## CITY OF PATASKALA BOARD OF ZONING APPEALS

### STAFF REPORT

#### Transportation Corridor Overlay District Application TCOD-21-005

### TCOD-21-005 Review

1 LANDSCAPE PLAN  
SCALE: 1/20" = 1'-0"

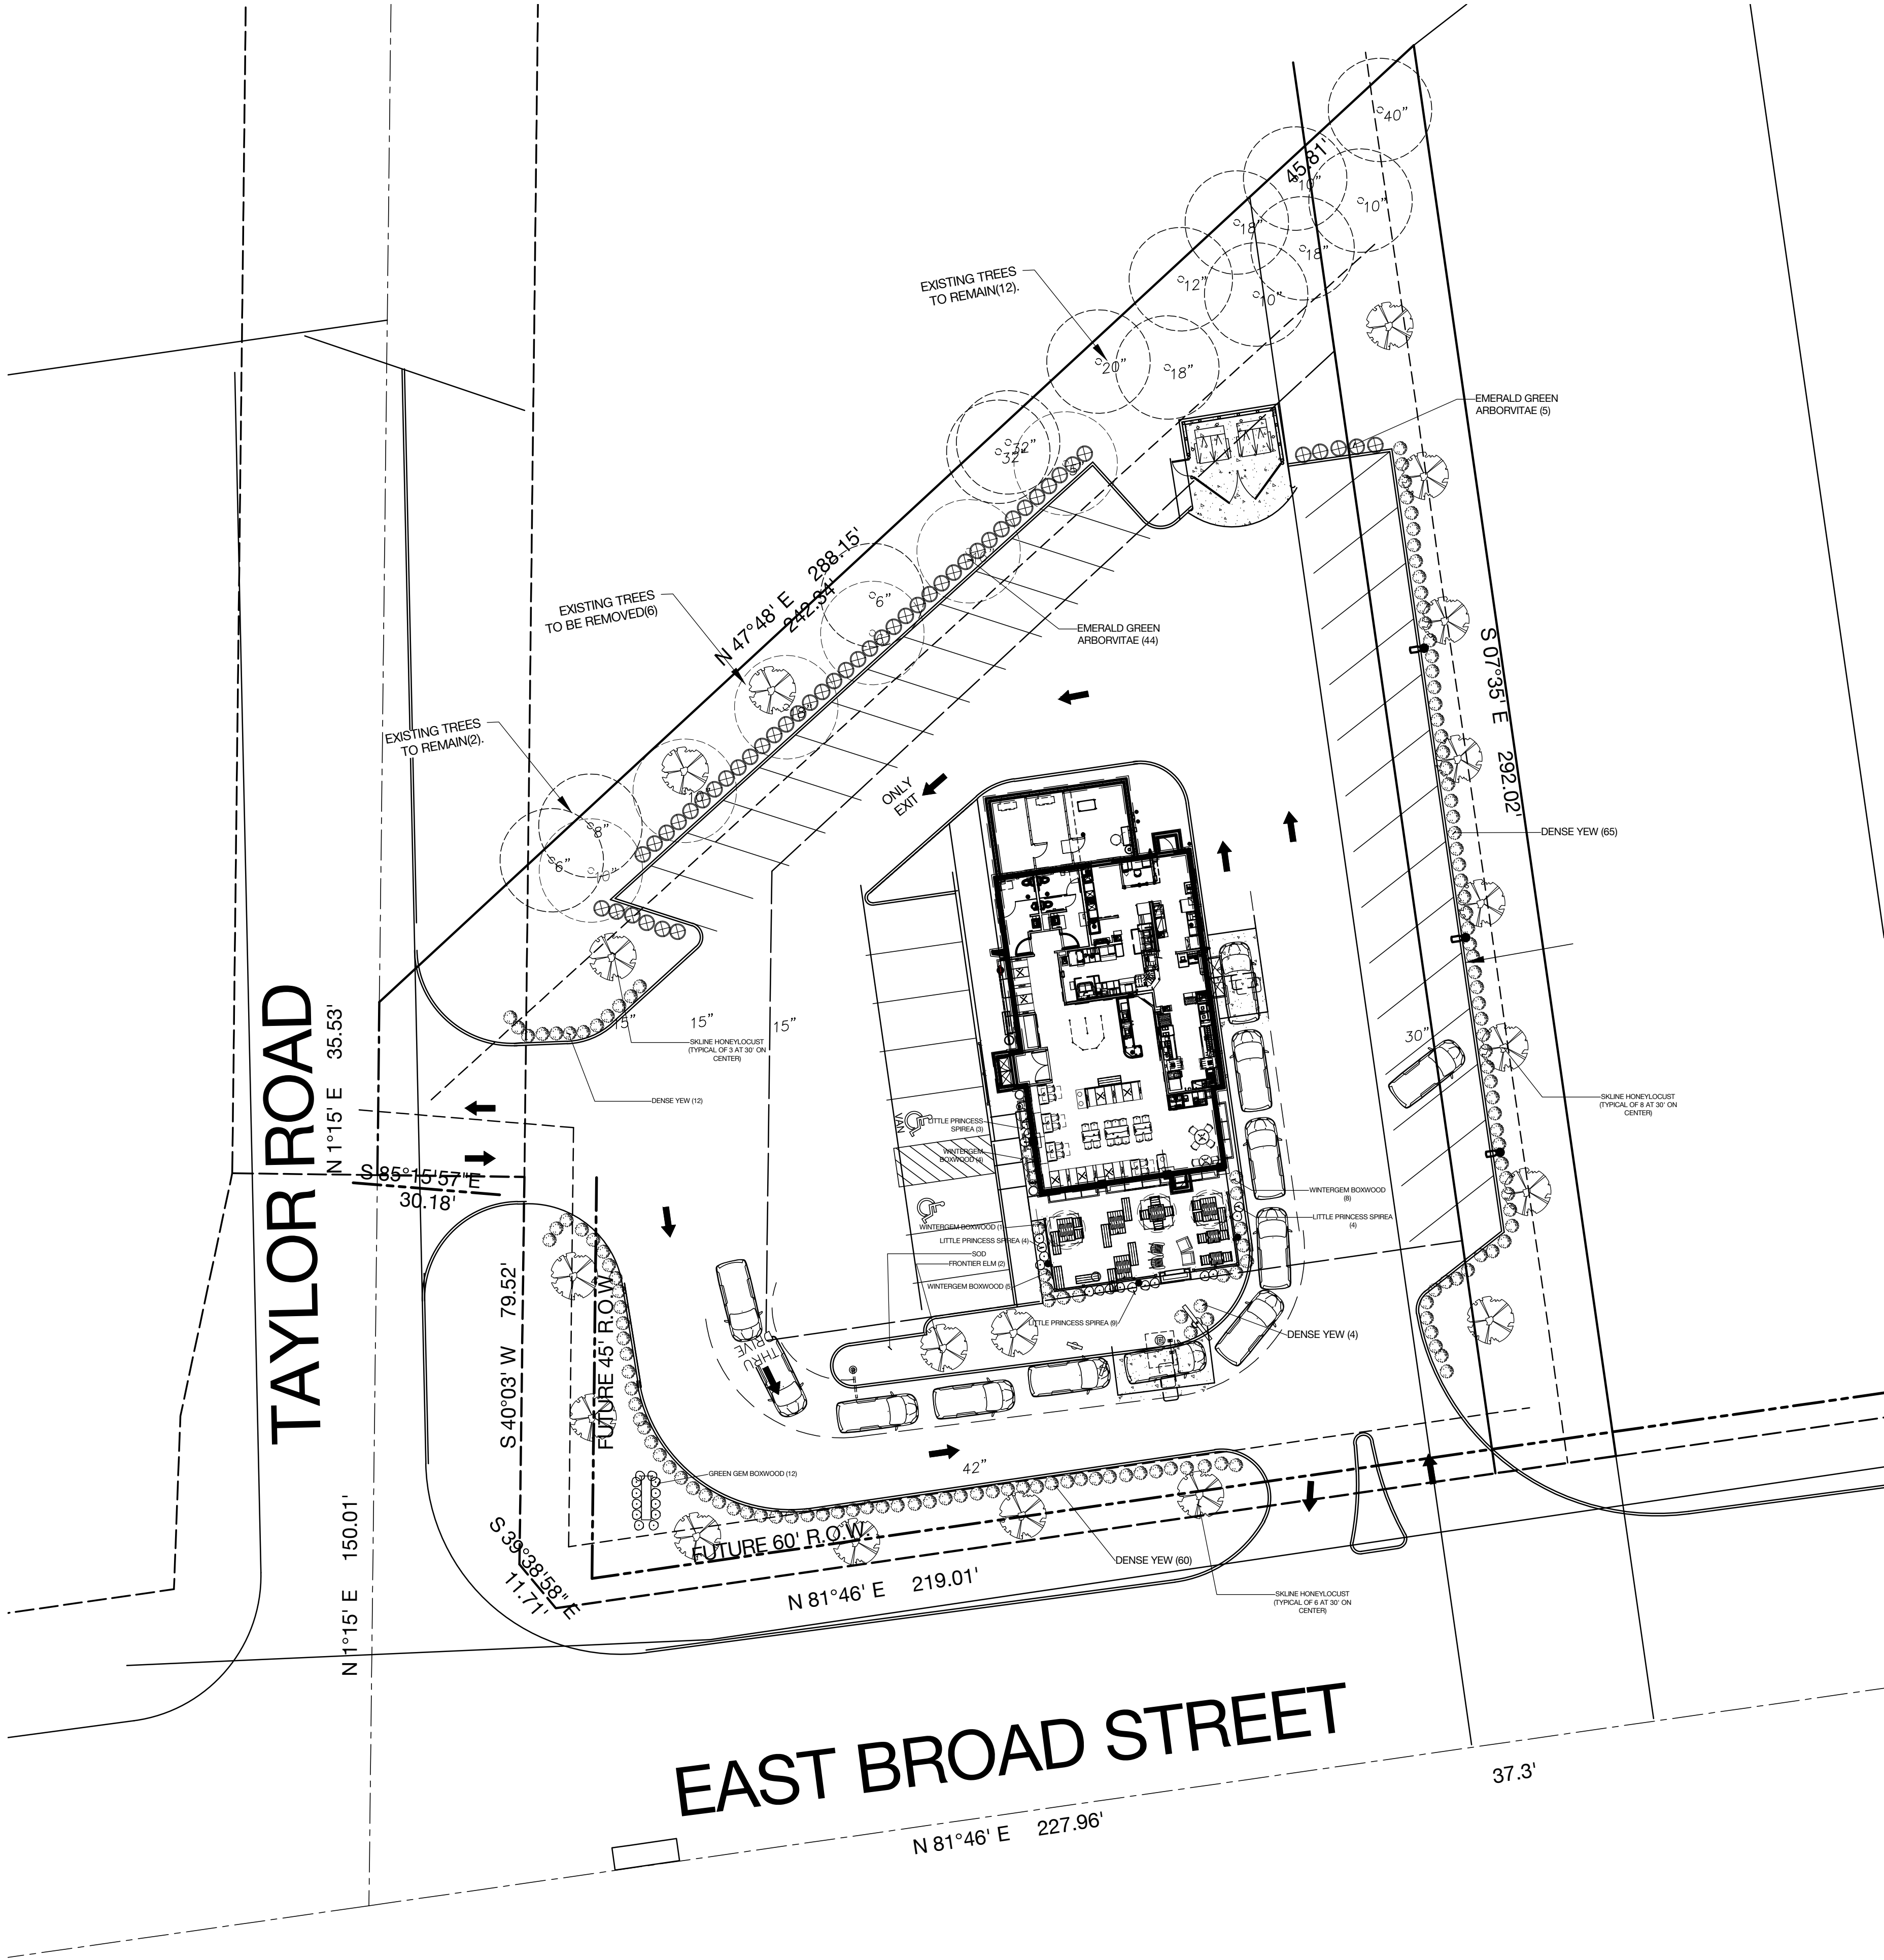
The Demo Plan (Page L100) indicates a total of 11 trees to be removed from the site. Five (5) of these trees would fall under the replacement exemptions from Section 1283.03(B)(1)(a-d) and one (1) is below the 6-inch replacement threshold. This leaves five (5) trees that are being removed that are within the replacement requirements that are unaccounted for. Pursuant to Section 1283.03 of the Pataskala Code; these trees would either need to be replaced on site at an appropriate ratio, or the developer would need to contribute to a fee-in-lieu.

- Any tree over 6 inches (as in 1259.05(G)) shall be preserved where possible. If being removed, then a tree must be replaced at an appropriate ratio as determined by Table 1283.03-01 and Table 1283.03-02. A developer may also contribute to a fund in lieu of replacements at a 3:1 ratio.
  - Demo Plan shows total of 11 trees being removed. 5 of these would fit under the exemptions 1283.03(B)(1)(a-d), 1 is below the 6-inch threshold. This leaves 5 trees that are being removed (10", 10", 18", 6", 18") that are unaccounted for. We will need to know how these are being replaced, or if they will be contributed to the fee-in-lieu.

2 BUILDING SIGNAGE

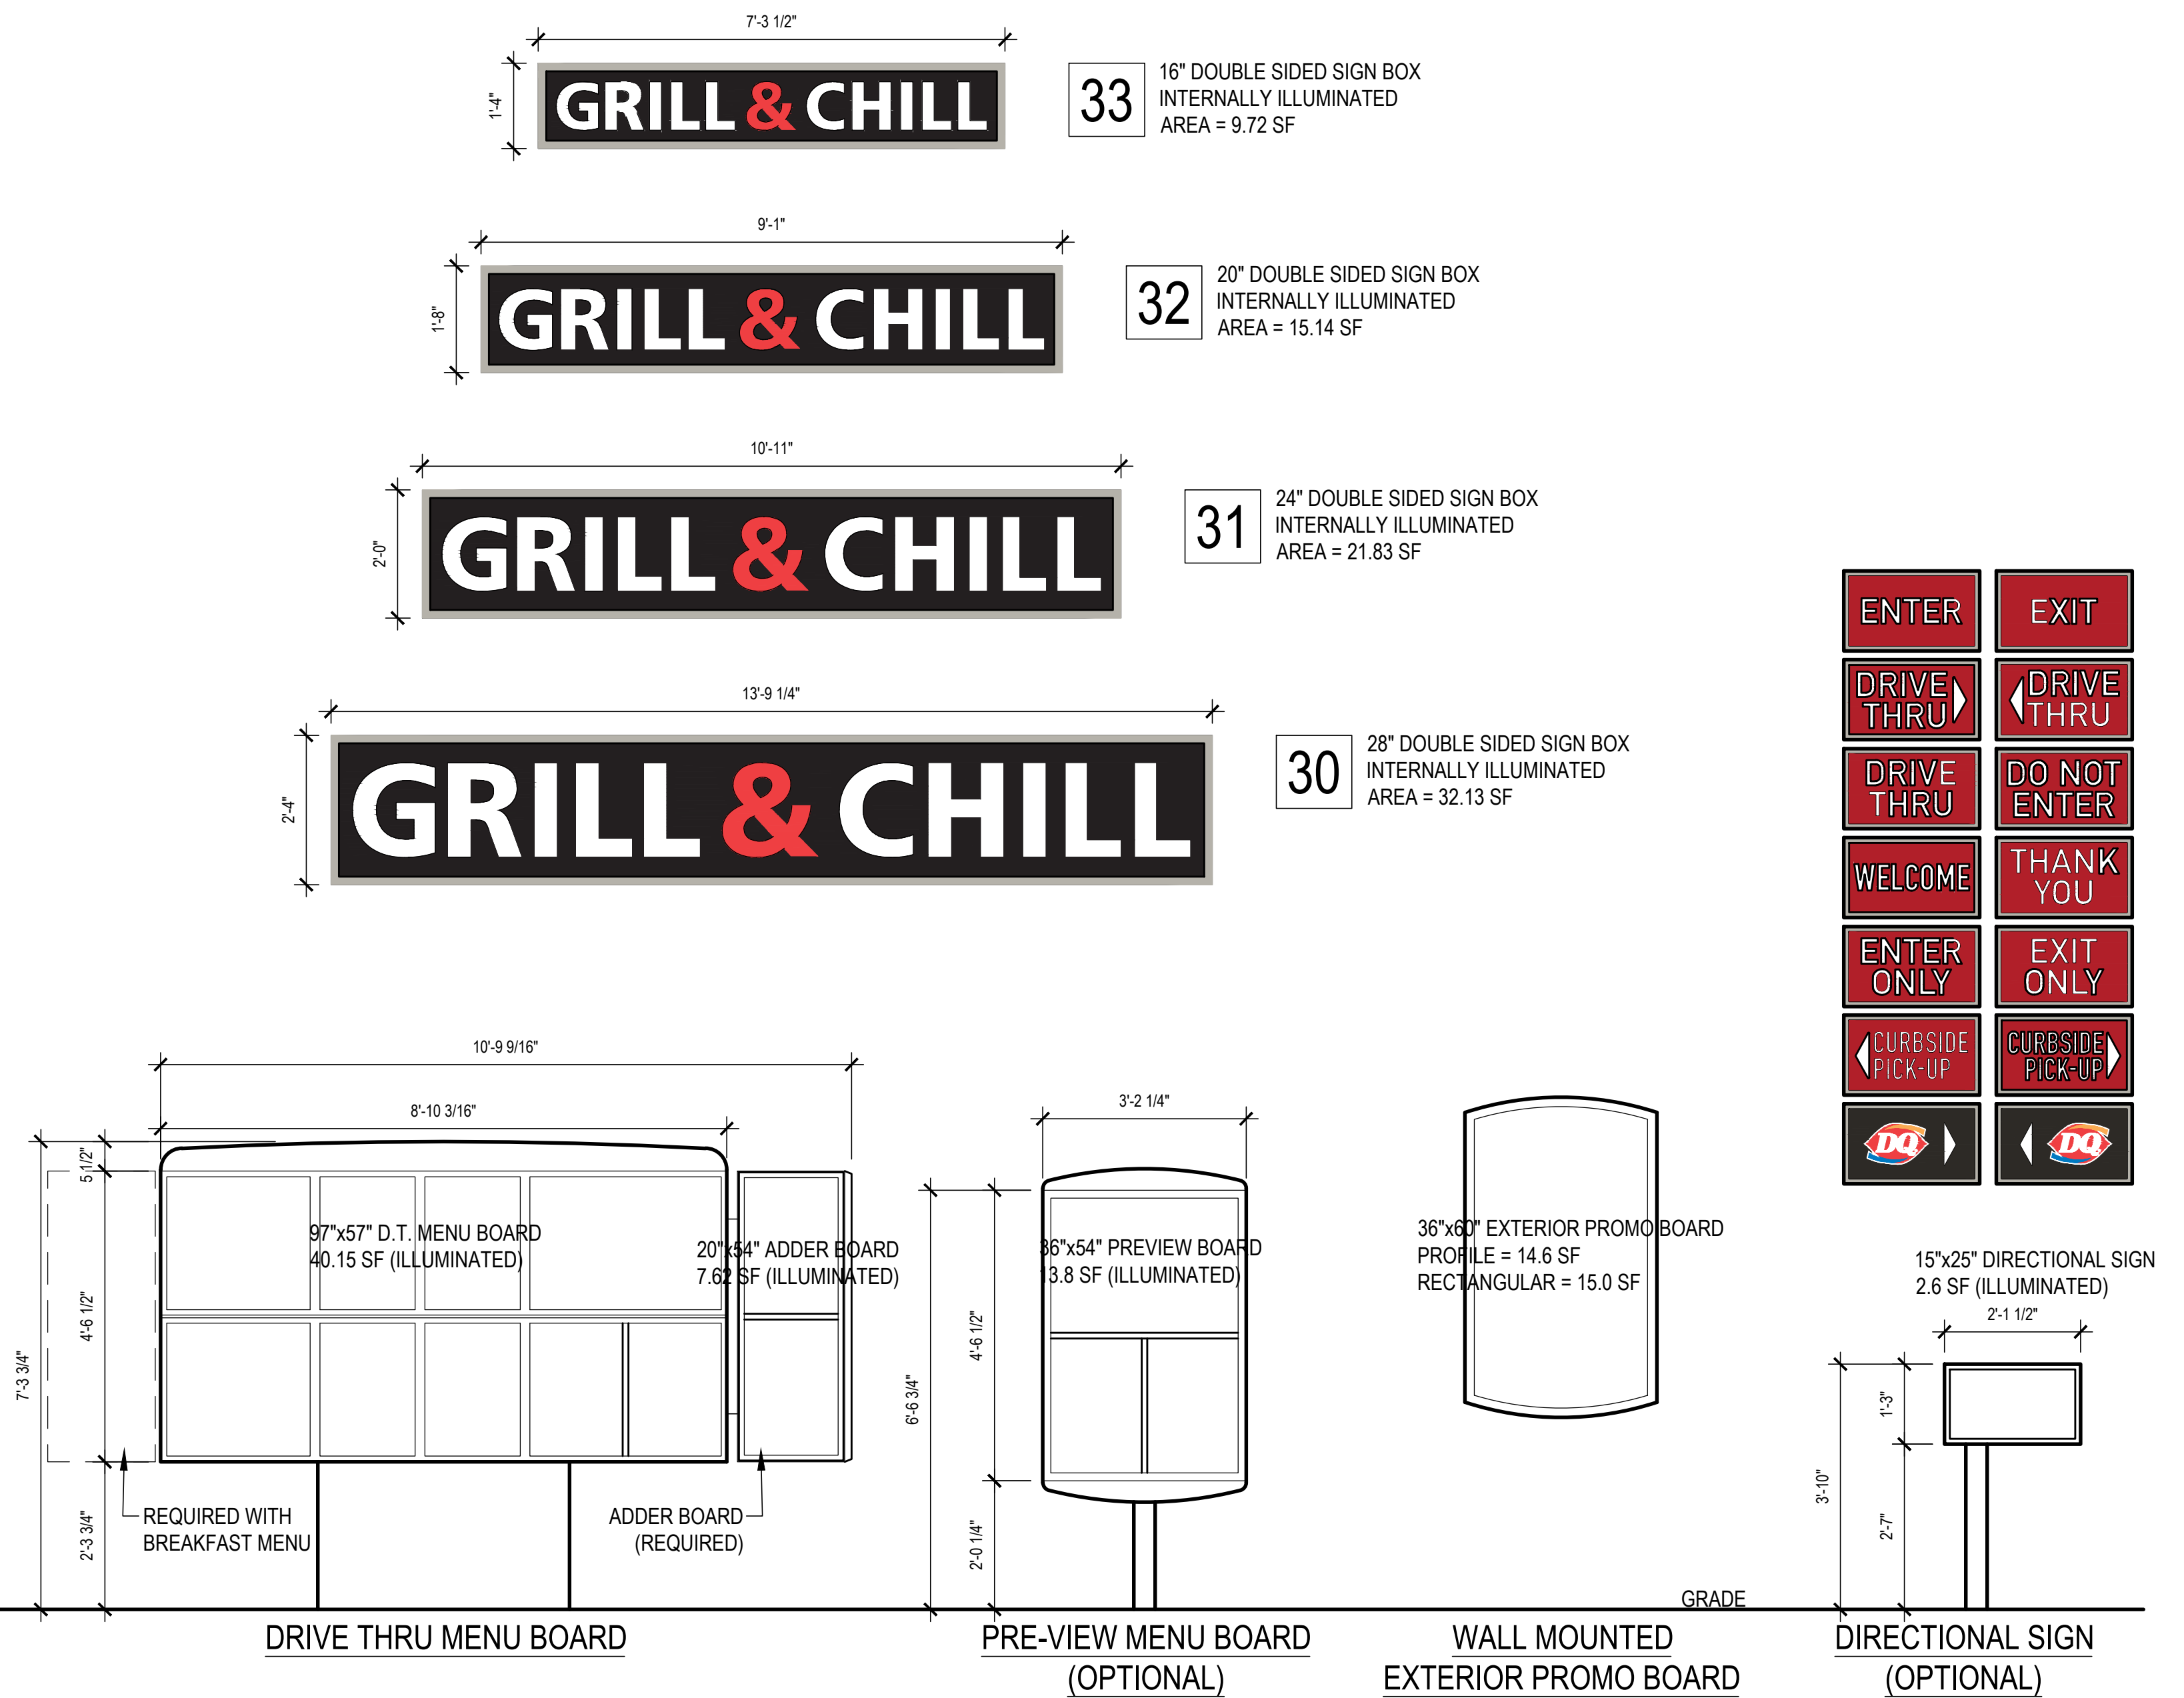
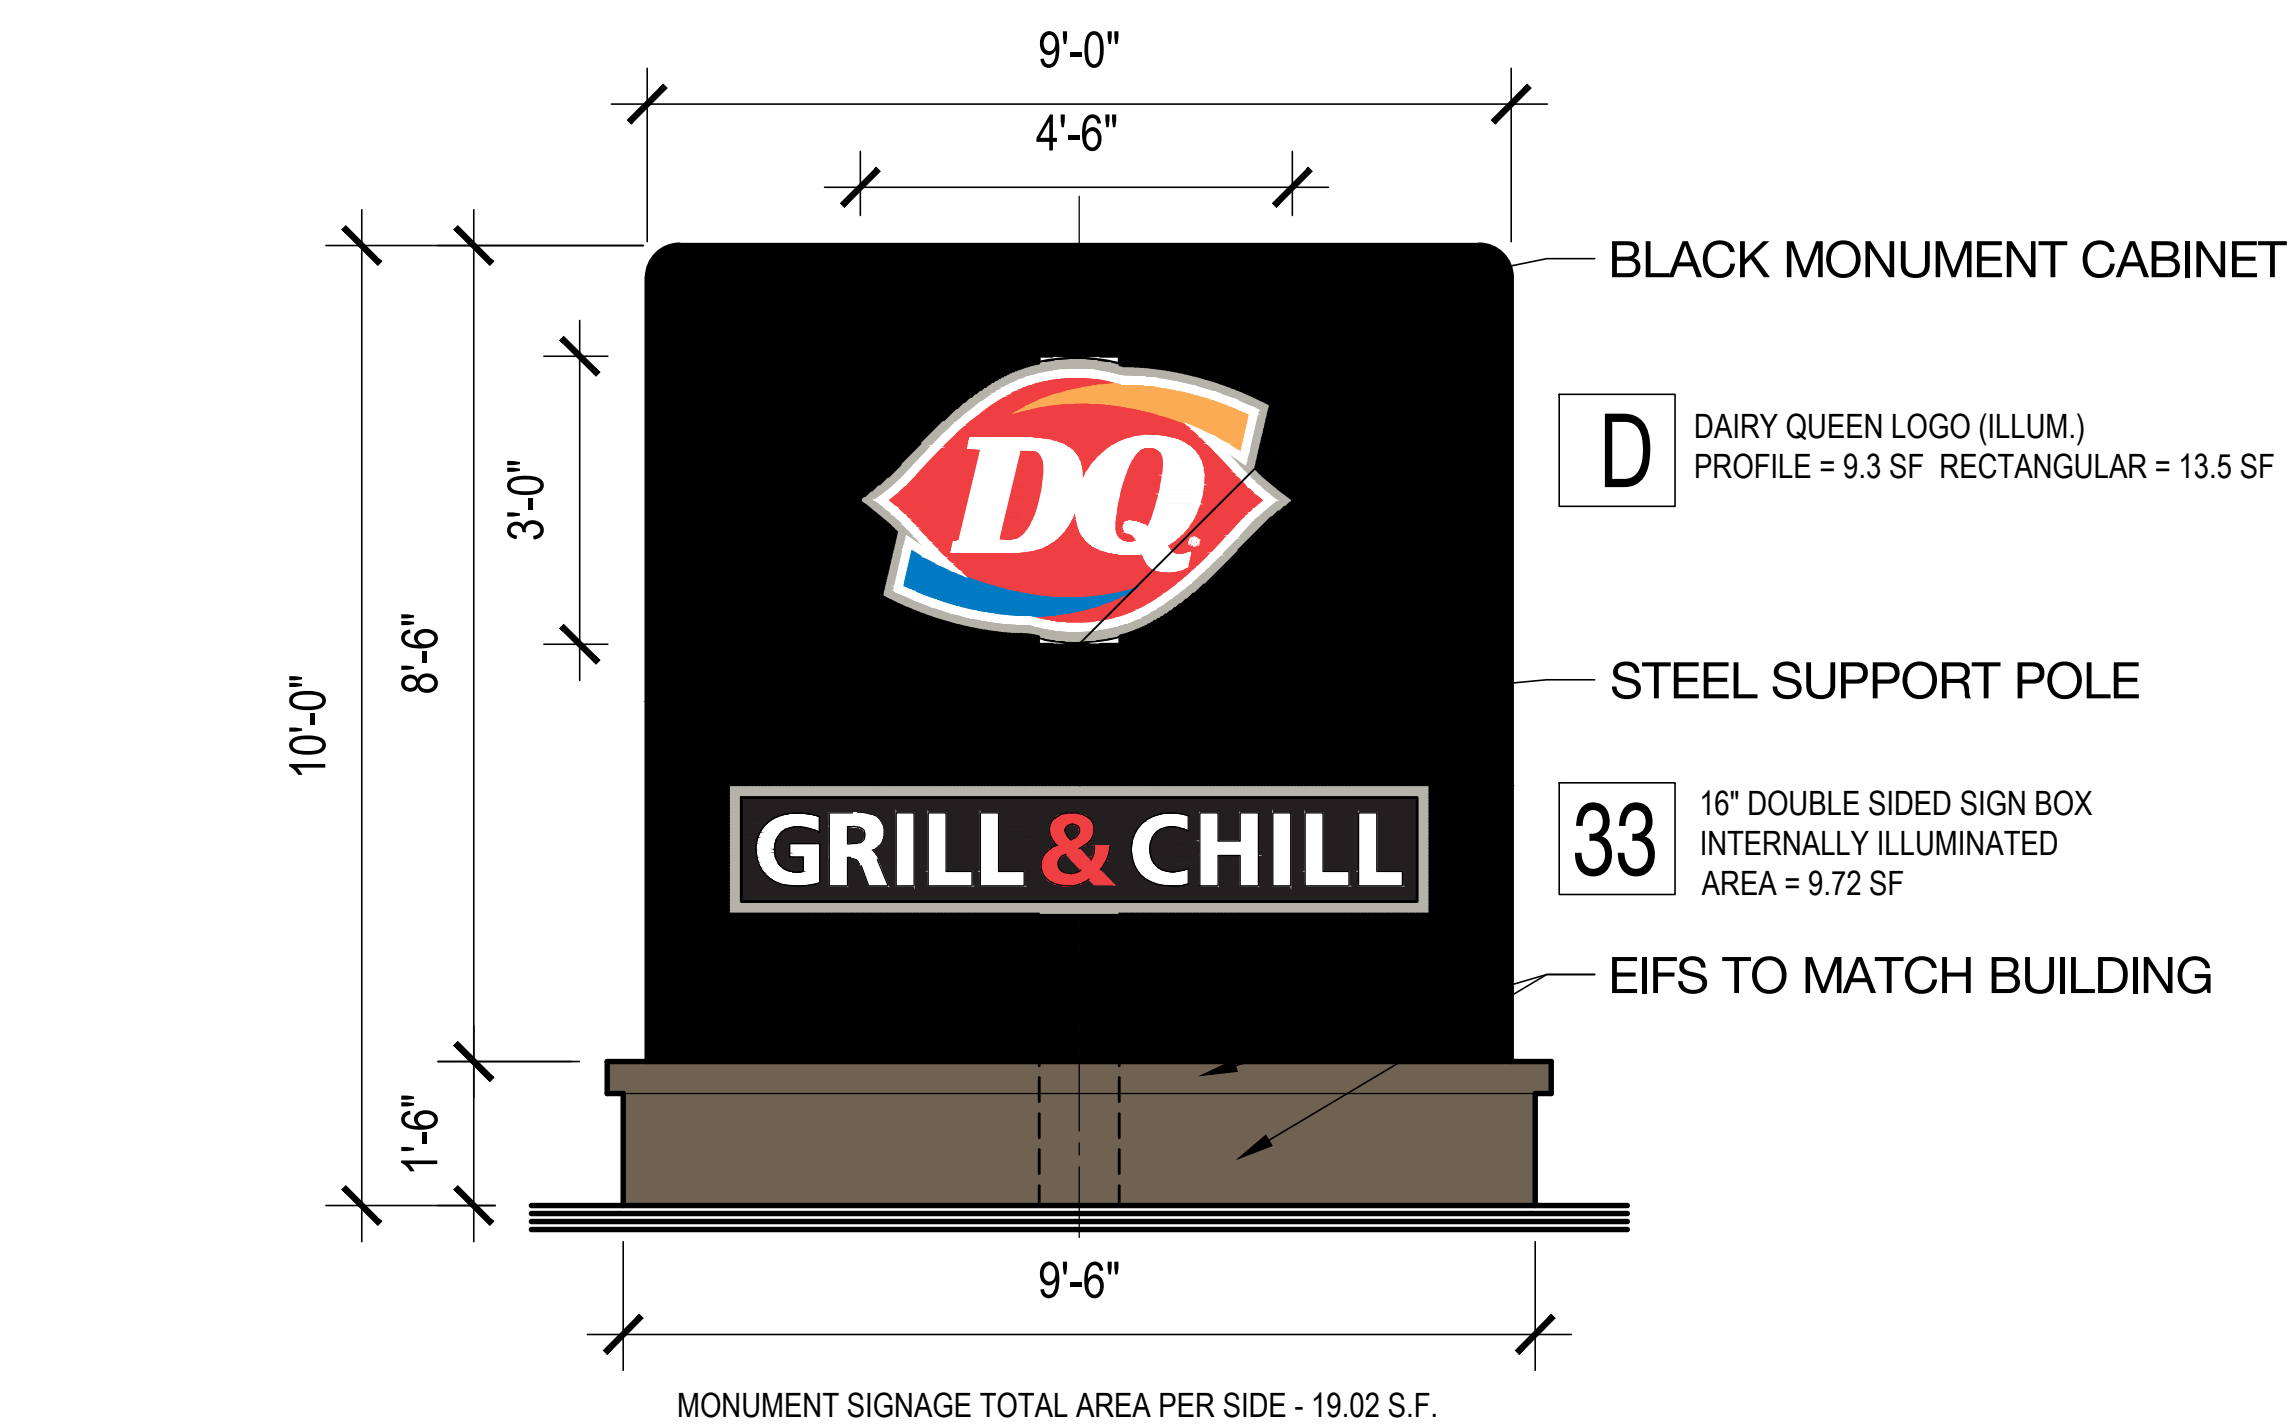
The proposed signage plan does not meet the requirements of Chapter 1295. A full list of comments is in the attached review page. Per Chapter 1295 business lots are allowed one wall (1) sign per face of the building fronting a public street, not to exceed 32-square feet, and one (1) ground sign. The ground sign is in compliance; however, the wall signs exceed the total number and maximum square footage permitted per building frontage. The Applicant will either need to adjust their signage plan into conformance with the code or receive a Variance from the Board of Zoning Appeals for the proposed signage.

- 6 total wall signs proposed (B, C, 102, spoon and blizzard sign)
      - 2 on E. Broad Street frontage
      - 4 on Taylor Road Frontage.
    - Total Square Footage of signage per frontage is over the maximum of 32-square feet.

- There are a couple signs on Page A303 which are not identified on the layout plan on Page A301 (Signs: A, D, 102, 103, 104, 32, 31, and 30).
  - 1295.09(b)(3)(B): Wall signs shall not extend more than 15-inches from the face of the building to which they are attached
